STATE OF OHIO
DEPARTMENT OF HIGHWAYS

PERMIT - No. 65-377

County of Warren Div. 8S.R. 122 Sec. 0089-0.94Date July 14, 1965To Mr. F. G. Kepler, Supervisor of Permits Attention: _____From Mr. R. W. Keller, Prof. Engr.Subject Proposed Multiple Pipe Culvert under Proposed Standard Oil Co. Drive at the intersection of S.R. 122 and Northbound entrance ramp to I-75.

Bridge No. Pipe Structure
under Standard Oil Service
Station Entrance

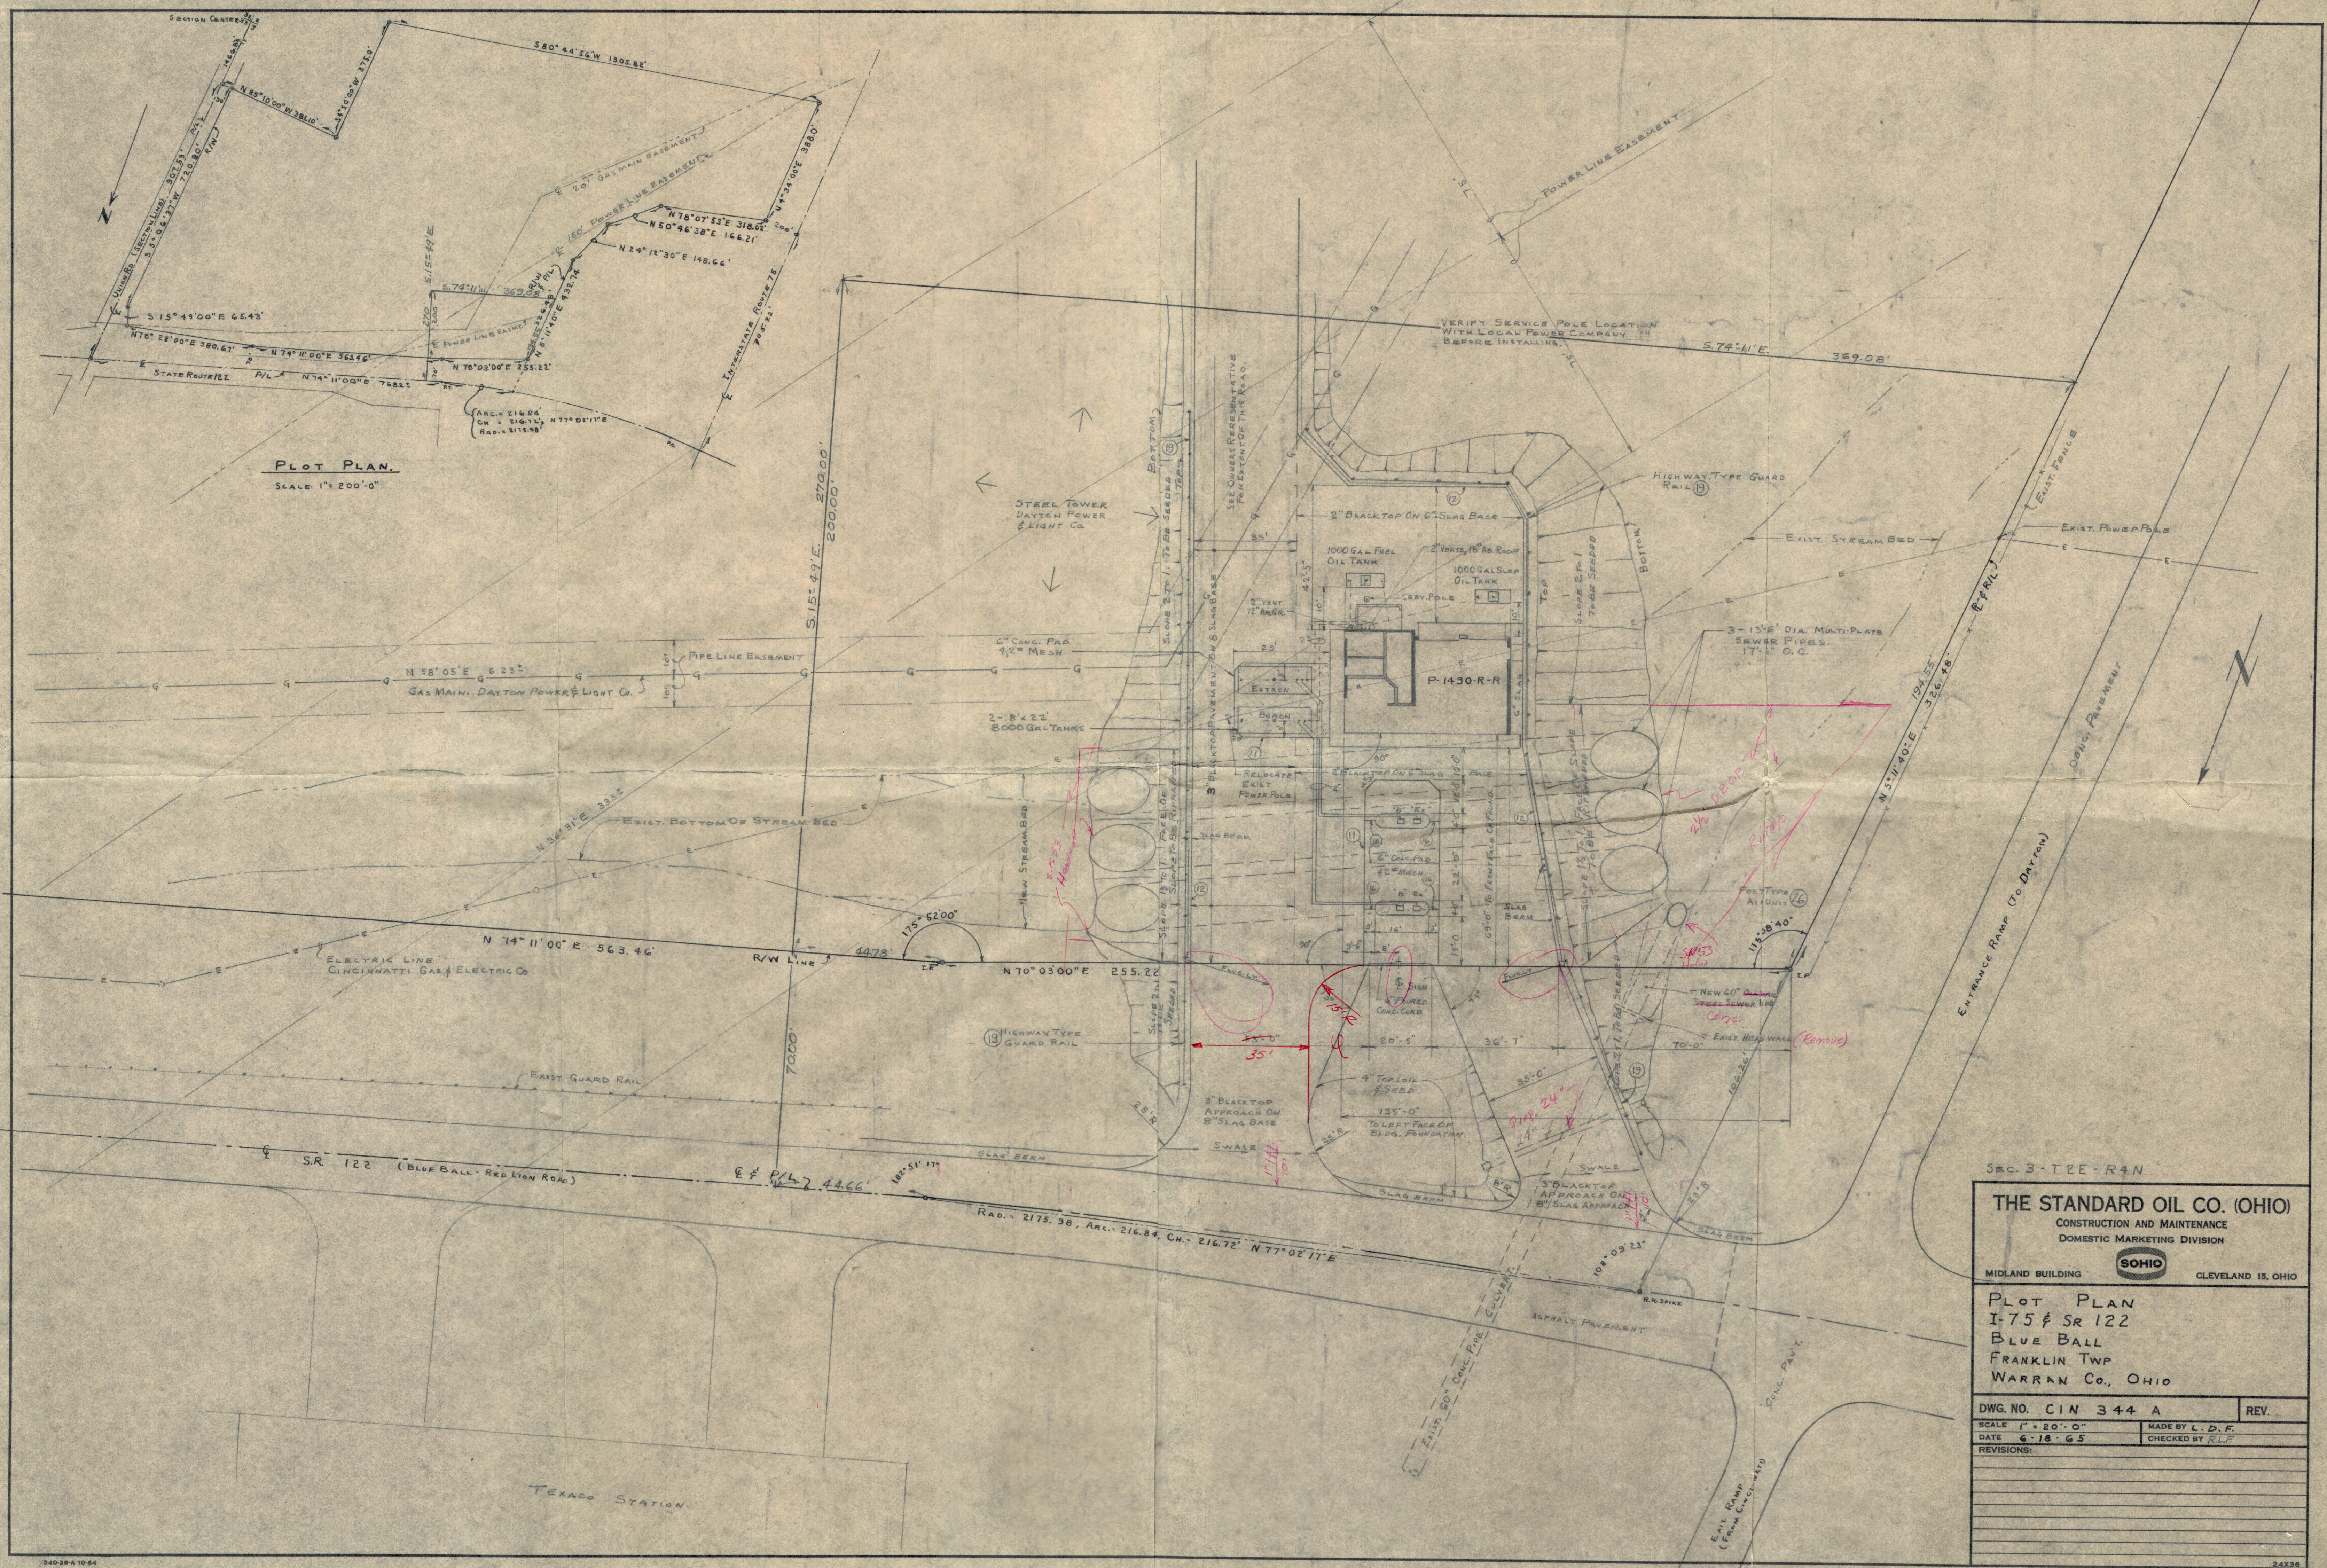
We have shown, in red, on the attached print an acceptable design for the west drive. The slight encroachment over the L.A. R/W of the 25-foot radius on the east approach is not objectionable in this instance since a change in the approach angle could result in a smaller radius being used.

No review of the drainage has been made by this office; however, we concur in the recommendation that a plan should be prepared, before the permit is approved, which shows the detail of protection of the drainage outlet. This should also include a detail for the protection of the ramp embankment. Also, since parking inside the service station property will be restricted, consideration should be given to leaving the intermediate island area depressed in order to discourage parking in this area.

We suggest increasing the angle of the west approach in order to avoid encroaching on the limited access of I. R. 75, and provide a 15' or 25' radii from the west edge of the east approach to the right of way line.

We also suggest eliminating the 12" pipe across the west approach and constructing a catch basin in the area between the two approaches, outletting the catch basin with a 12" pipe into the 13'6" pipe culvert. This can be accomplished by warping both approaches to drain into the center median.

The proposed multiple pipe culvert of 3-13'-6" diameter pipes was review^{ED} and found to^{BE} adequate to carry a twenty-five storm^{YEAR} frequency.

It is suggested, however the proposed multiple pipe culvert be lowered a foot below the proposed indicated flow line elevation which would place the structure a foot below the channel at the bridge. Also it has been assumed that before final approval the detail of protection of the outlet end with concrete riprap will be shown in the final plans.

This structure is quite adequate as to waterway capacity, however, a headwall similar to our SP53 headwall should be provided on the inlet end to compensate for flotation forces. We concur with Mr. Keller's comments that the flow line should be lowered one ft. and that adequate bank protection should be provided on the exposed bank of the interstate ramp opposite the outlet of this structure.

It would appear to us that this structure is more expensive than a reinforced concrete slab structure and not as desirable hydraulically as a three span reinforced concrete slab structure or a capped pile substructure would be. However, subject to the above comments, we offer no objection to the use of three 13'-6" CMP pipes as proposed.

The proposed multiple pipe culvert shall be lowered a foot below the proposed indicated flow line elevation. An SP-53 headwall or equal shall be constructed on the inlet end and concrete riprap protection provided on the outlet end, also dumped rock channel protection 2-1/2' thick shall be placed in the stream bed at the outlet end.

pipe extended with approximately 35' of 60" concrete pipe with an SP-53 head-wall or equal and riprap provided, as shown in red.

Riprap shall be placed on the exposed bank of the stream along the interstate ramp opposite the outlet end of the multiple pipe culvert and shall be equal to one-half the height diameter of the multiple pipe culvert above the flow line and shall also have a toe wall of 12" reinforced concrete.

The two approaches shall be constructed as shown in red and maintain a 1" per foot slope away from the edge of pavement of S. R. 122 for 10' to insure no drainage onto S. R. 122.
